UNITED STATES PATENT AND TRADEMARK OFFICE

APPLICATION NO.	FILING DATE	FIRST NAMED INVENTOR	ATTORNEY DOCKET NO.	CONFIRMATION NO.
10/707,184	11/25/2003	Peter T. Kazlas	H-360	1183
26245	7590	12/28/2007	EXAMINER	
DAVID J COLE			NGUYEN, KHIEM D	
E INK CORPORATION				
733 CONCORD AVE			ART UNIT	PAPER NUMBER
CAMBRIDGE, MA 02138-1002			2823	
			MAIL DATE	DELIVERY MODE
			12/28/2007	PAPER

Office Action Summary

DETAILED ACTION

Figure 3

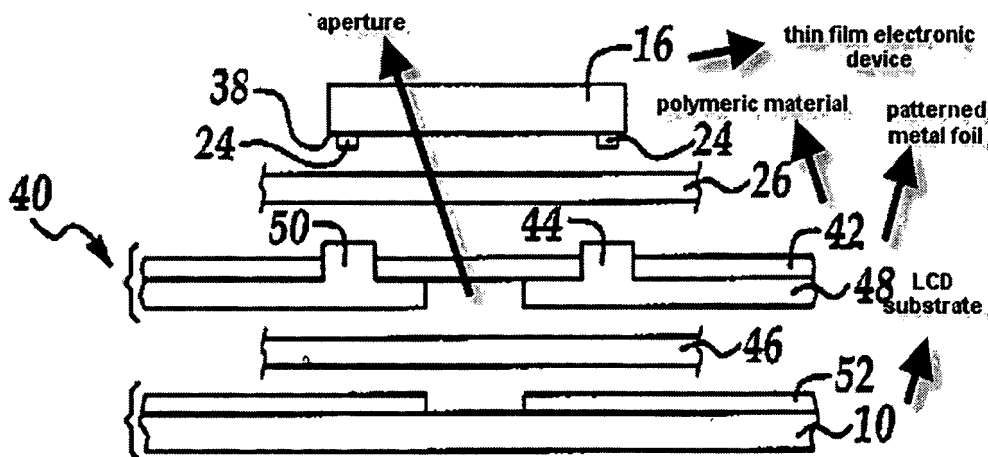
In re claim 1, Yang et al. disclose a backplane for use in an electro-optic display, the backplane 40 comprising a patterned metal foil 48 having an aperture extending therethrough, coated on at least one side with an insulating polymeric material 42 (see col. 6, lines 11-33), and having an thin film electronic device 16 provided on the insulating polymeric material 42, whereby the insulating polymeric material 42 separates the thin film electronic device 16 from the patterned metal foil 48 (see col. 6, lines 34-41 and FIGS. 3-4 for example).

However, Yang et al. is silent about the backplane comprising a patterned metal foil having a plurality of apertures extending therethrough and having a plurality of thin film electronic devices provided on the insulating polymeric material.

FIG. 5B

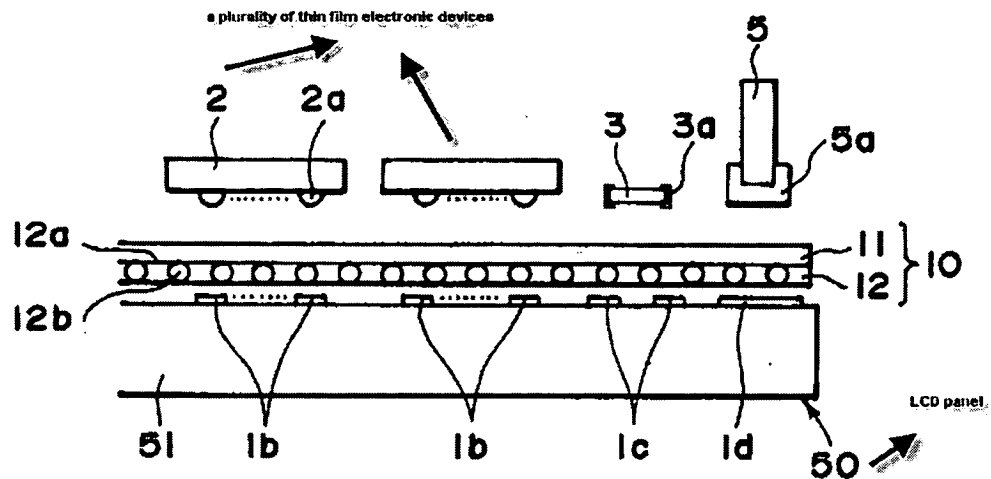
Takabayashi et al. disclose a backplane for use in an electro-optic display, the backplane comprising a plurality of thin film electronic devices 2 provided on the liquid crystal display (LCD) substrate 50 (see col. 8, lines 42-59 and FIGS. 5B, for example).

As Takabayashi et al. disclose, one of ordinary skill in the art would have been motivated to provide a plurality of thin film electronic devices on the insulating polymeric material in order to obtain a multi-element module and a production process capable of suppressing an increase in production costs and preventing a lowering in production yield (see col. 3, line 65 to col. 4, line 7 of Takabayashi et al.).

Figure 3

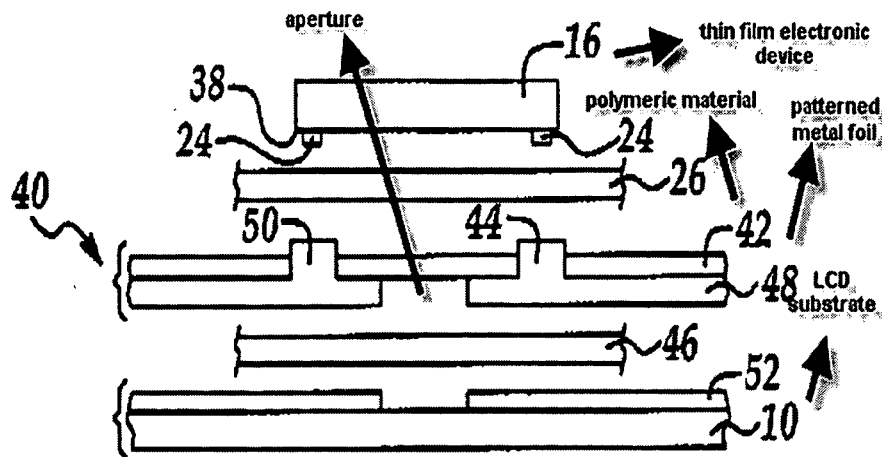
In re claim 12, Yang et al. disclose a backplane for use in an electro-optic display, the backplane comprising a metal foil **48** coated on at least one side with an insulating polymeric material **42** (see col. 6, lines 11-33) and having an thin film electronic device provided on the insulating polymeric material **42**, (see col. 6, lines 34-41 and FIGS. 3-4, for example), the backplane further comprising at least one conductive via **44**, **50** extending through the polymeric material **42** and electrically connecting at

least one of the thin film electronic device 16 to the metal foil 48 (see col. 6, lines 28-64 and FIGS. 3-5, for example).

However, Yang et al. is silent about a plurality of thin film electronic devices provided on the insulating polymeric material.

Figure 3

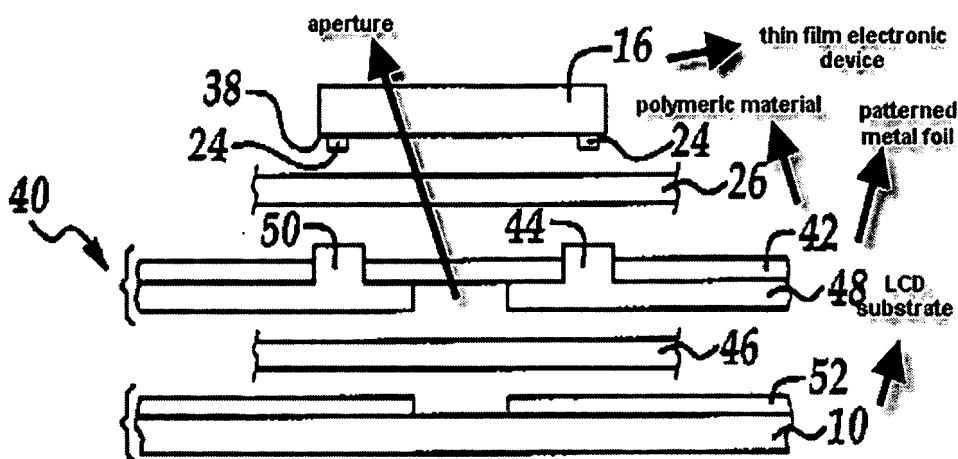
In re claim 24, Yang et al. disclose an electro-optic display having a metal substrate 48, the display having a central portion comprising an electro-optic material and means for writing an image on the electro-optic material (see col. 6, lines 11-13), and a peripheral portion extending around at least part of the periphery of the central portion, the peripheral portion having an aperture extending through the metal substrate 48, by

means of which apertures the electro-optic display may be stitched to a flexible medium (see col. 6, lines 16-64 and FIGS. 3-5, for example).

However, Yang et al. is silent about a plurality of apertures extending through the metal substrate.
